Technical Evaluation Report

For F-Area Tank Farm Facility,
Savannah River Site, South Carolina

Final Report

U.S. Nuclear Regulatory Commission
Office of Federal and State Materials
and Environmental Management Programs
Washington, DC 20555-0001

Figure 3-10 Tank 18 and 19 Volume Distribution Following Mantis Cleaning (SRR-CWDA-2009-00030)

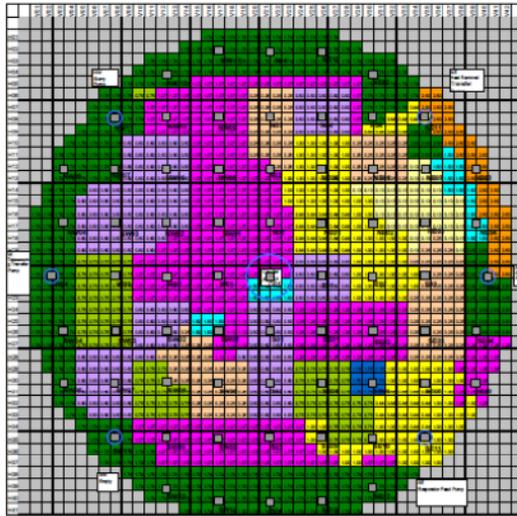
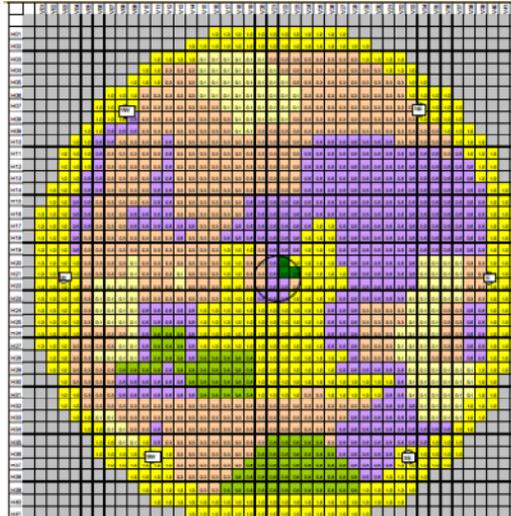
DOE does not fully evaluate the basis for differences in removal effectiveness both within each tank and between Tanks 18 and 19, and how these differences are accounted for in the determination to cease cleaning operations. As shown in Figure 3-10, there is variability in depth across the floors of each tank, and also a considerable difference in how effective the technologies were for Tank 18 in comparison to Tank 19. For example, there is a greater amount of residual material in the center of Tank 18 as well as to the northwest and south. The mound in the north region of Tank 18 that formed after the use of the ADMP may have contributed to variability prior to using the Mantis, but DOE does not describe why the Mantis may have been less effective in this area or in the southern most part of Tank 18. As discussed above, the Mantis could have been less effective in these areas due to the travel limitations that are presented in a separate reference (U-ESR-F-00041) describing the use of the Mantis in the volume mapping (see Figure 3-10), but DOE does not draw a link between Mantis travel limitations and cleaning effectiveness. Also, the difference in effectiveness of similar cleaning technologies is surprising, especially given the similarities in the tank designs and because Tank 18 was predicted to have a much lower volume of waste than Tank 19 at the end of Phase 3. Differences between the waste in Tanks 18 and 19 that may have affected waste retrieval are not clear, and in fact some descriptions indicate that waste is identical (DOE-WD-2005-002, Rev. 0) while other descriptions indicate that the waste in Tank 19 was more amenable to retrieval (e.g., V-ESR-G-0003 describes Tank 19 waste as more sand-like compared to Tank 18). The Mantis technology was first operated in Tank 19, so it would seem that lessons learned from that operation could potentially increase performance in Tank 18. Equipment malfunctions occurred during retrieval efforts in both Tank 18 and Tank 19, but the Tank 18 Mantis was operated without the forward/downward spray or the ability to tilt the crawler for some period of operation. Furthermore, the Tank 18 travel limitations may have put additional constraints on waste retrieval. DOE does not fully describe if this variability within and between tanks was anticipated. DOE does not explain why methods to improve the effectiveness of the selected technology was apparently less successful in Tank 18.

Figure 4-5 Evolution of the pH of Tank Backfill Grout, Comparing Measured Column Data to Model Results

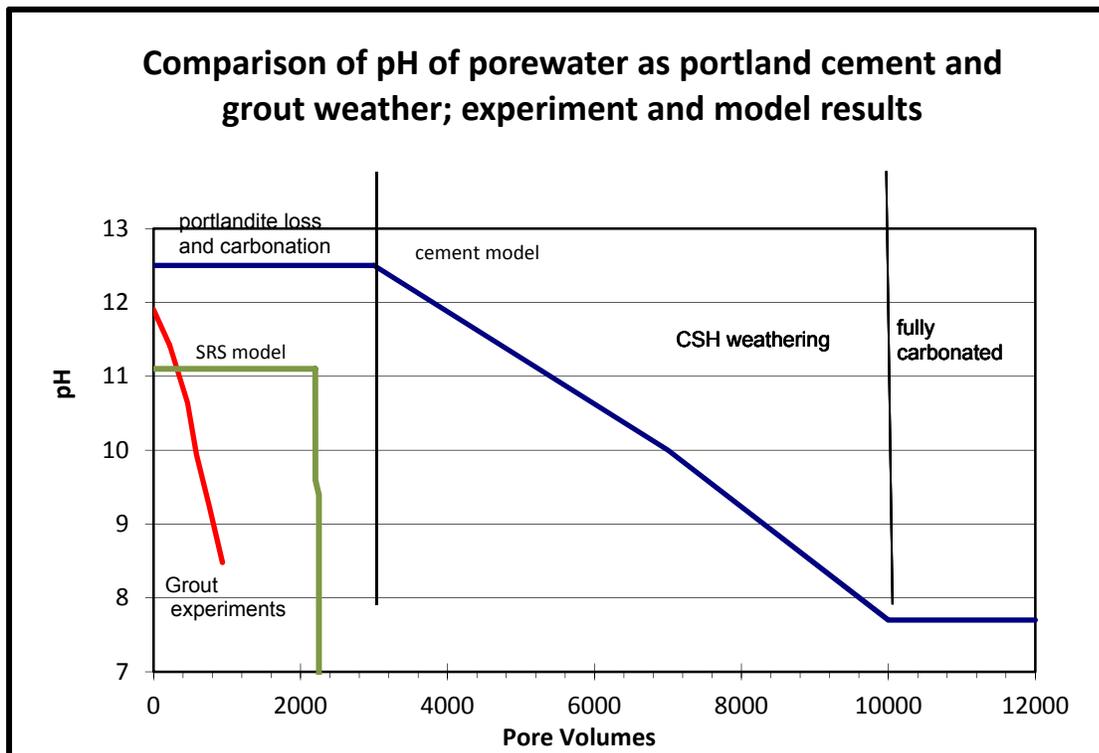
NRC staff is not convinced that a step function as used in the PA is appropriate. The experimental column data in Figure 4-5 indicates that rubblized reducing grout attains a pH of

around 8.4 in just less than 1000 pore volumes. As a result, it is extensively carbonated. While the water used was a bicarbonate groundwater (synthesized), NRC staff think that the essential trend would be similar using SRS water. The difference in behavior suggests that the basic assumptions of solid phases within the grout are erroneous. It is unclear what the chemical effects will be on radionuclide dissolution and their subsequent retention/mobilization. However, the difference in observed versus modeled pH evolution suggests that modeled redox behavior may be different as well. It will be important to provide experimental support of modeling results for a parameter as important as pH.

Given the observed changes of pH over about 1,000 pore volumes (Figure 4—5) in grouts to be used for tank backfill systems, it becomes important to understand the solubility of key radionuclides as pH changes. In turn, if geochemical modeling is used to calculate solubilities, it is necessary to know the solid phases controlling their solubility because the solubilities of

Figure 4-9 Calibrated Horizontal Hydraulic Conductivity Assignments to the Regional GSA/PORFLOW Model (Fourmile Branch is South and Upper Three Runs Creek is North of the F-Tank Farm)

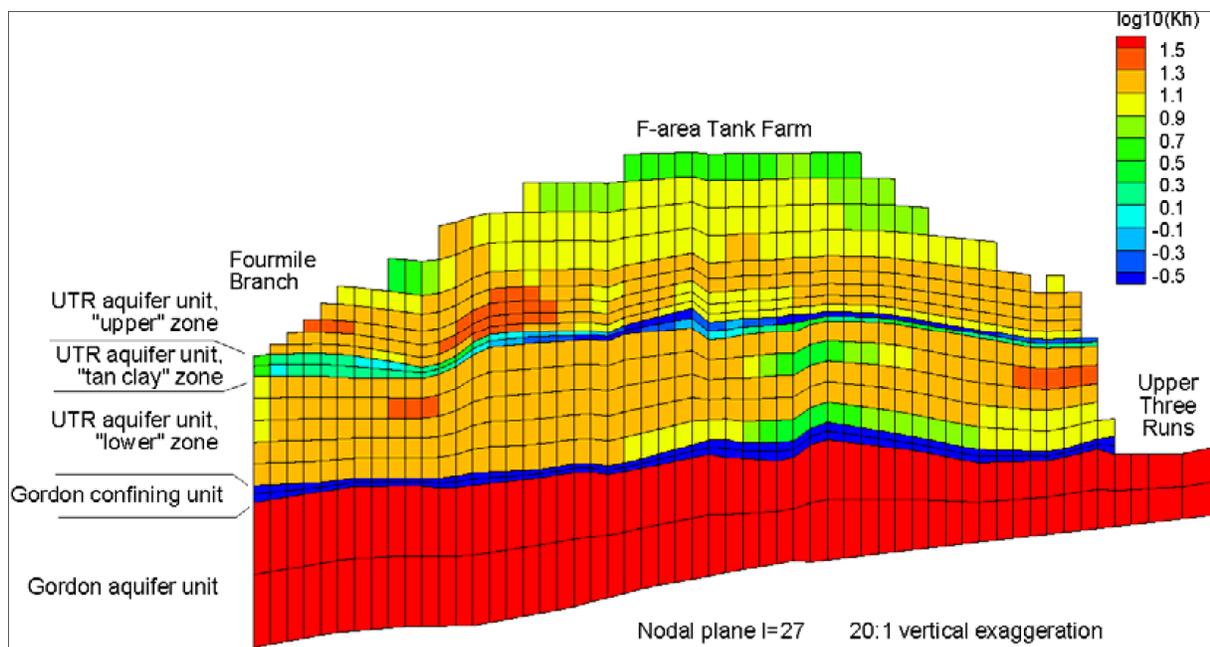
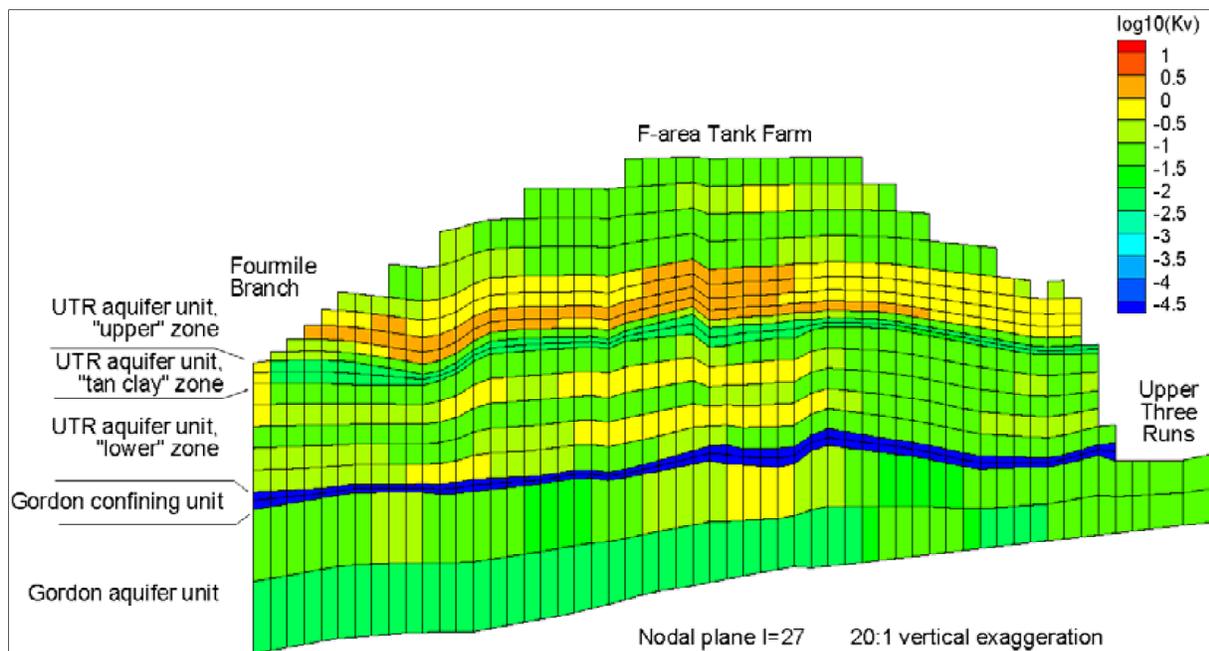
With respect to GSA/PORFLOW model calibration, the maximum hydraulic head residual in the UTR-LZ of 8.2 m (27 ft) (WSRC-TR-2004-00106) greatly exceeds the calibration goal of no more than 5 to 10 percent of the total hydraulic head variation in the UTR aquifer for the maximum head residual. The UTR-LZ exhibits large residuals where the water table drops sharply to the UTR creek and in the vicinity of H-Area (WSRC-TR-96-0399; WSRC-TR-2004-00106), but the well locations having the largest residuals are not in the vicinity of FTF (WSRC-TR-2004-00106, Figure 3-4(b)). Additional work may be needed to better define the hydraulic conductivity field in the vicinity of H-Area (WSRC-TR-96-0399; WSRC-TR-2004-00106), but relatively poor H-Area calibration should not affect the flow field and transport times from the FTF for the purposes of this PA. High residuals west and north of F-Area meet the calibration

Figure 4-12 Probabilistic Modeling Results (Peak Dose vs. Time, see July 19, 2011 RAI resolution meeting summary, ADAMS accession number ML112200656)

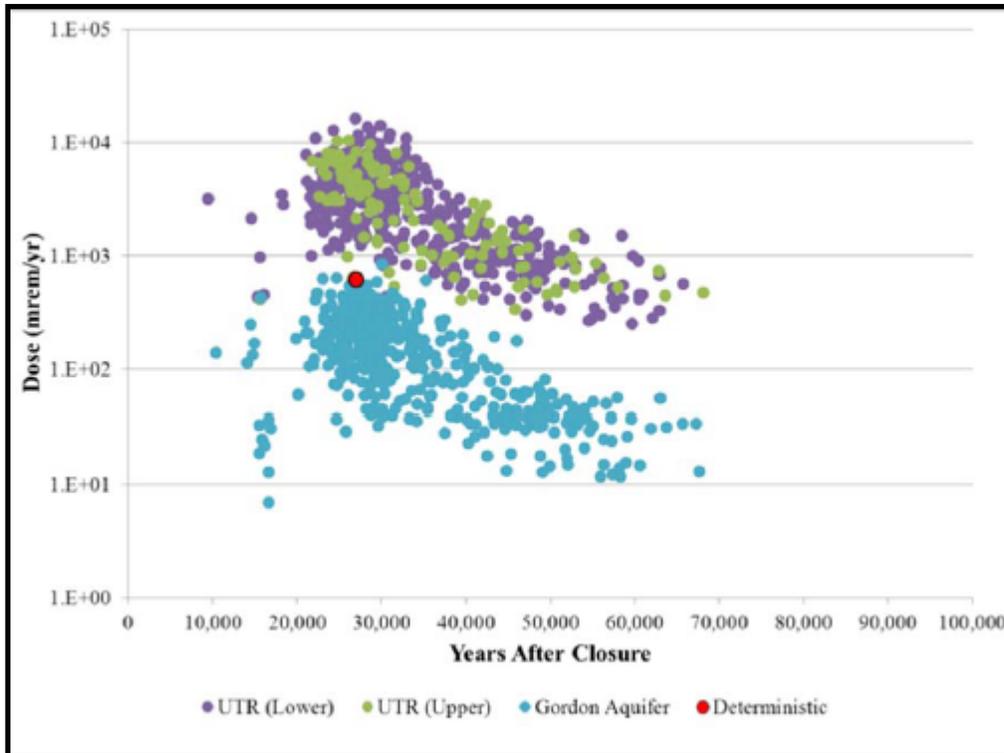
As discussed above, another important feature observed in Figure 4-12 provided by DOE following the June 28, 2011 RAI resolution meeting and discussed at the July 19, 2011 RAI resolution meeting (see Figure 1a in the attachment to the meeting summary found at ADAMS accession number ML112200656), is the appearance of two distinctly different data sets that are similar in shape and spread but only varying by roughly an order of magnitude. This result is due to a parameter assignment related to well completion. In the case of a well completed in the Gordon aquifer, DOE assumes a simple ratio between the UTR concentration and dose actually being simulated in the GoldSim and the concentration and dose in the Gordon aquifer.

The Gordon aquifer concentration and dose is not actually being calculated by GoldSim, but rather, is assumed to be a factor of 20 less than the UTR concentration. The probability of well completion in the Gordon aquifer is 40 percent. Thus, the peak doses for individual realizations depicted in Figure 4-12 occur in two distinct data sets separated by roughly a factor of 20 with realizations generally not overlapping between the two data sets over the same time intervals. Over all time, the two data sets overlap with uncertainty in the magnitude of the peak dose spanning roughly two orders of magnitude.

Figure 4-123 NRC Staff Alternative Presentation of DOE's Probabilistic Modeling Results

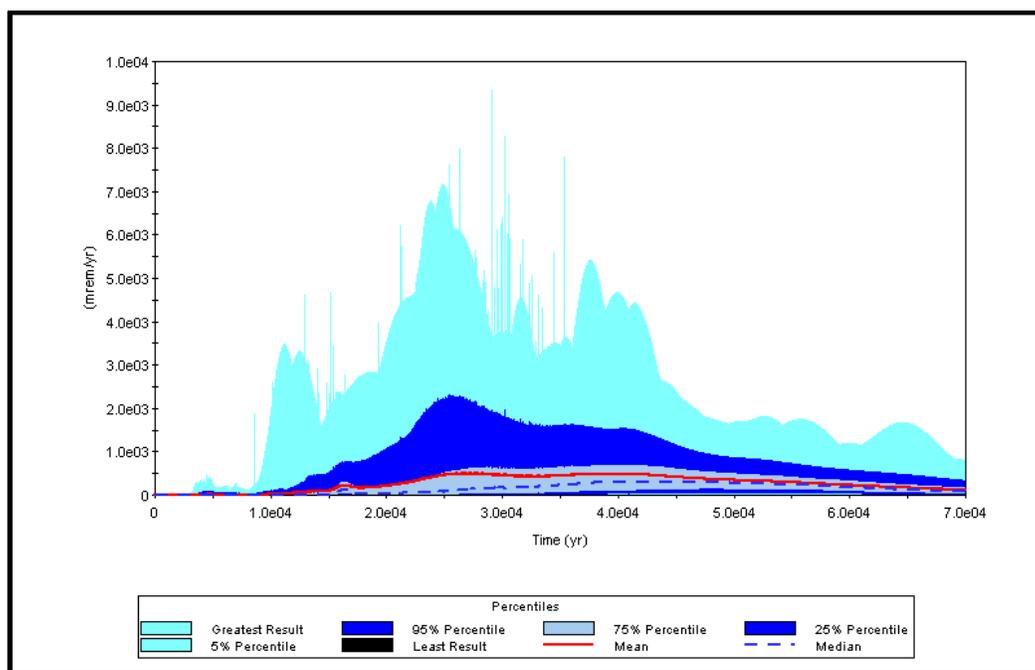
NRC staff also noted potential inaccuracies in the statistical information being presented in the PA due to the selection of a 1,000 year averaging time for plots in the probabilistic assessment. Furthermore, compliance with the performance objective in 10 CFR 61.41 should be against only those realizations with a well assumed to be completed in the UTR (and not the Gordon aquifer) as discussed in the July 21, 2011 RAI resolution meeting (ADAMS accession number ML112070958). Figure 5.6-38 in the PA (SRS-REG-2007-00002, Rev. 1) was replaced with another figure that considered (i) only those wells completed in the UTR, and (ii) used a plot time of 10 (rather than 1000 years). Figure 4-13 below shows NRC's attempt to provide more appropriate figure to assess compliance as an alternative to the one presented in DOE's PA Figure 5.6-38 (page 625 of SRS-REG-2007-00002, Rev. 1). The results shown in Figure 4-13 indicate a peak of the mean dose of around 0.20 mSv/yr (20 mrem/yr) over a 10,000 year period of performance and an overall peak of the mean dose of 5 mSv/yr (or 500 mrem/yr).
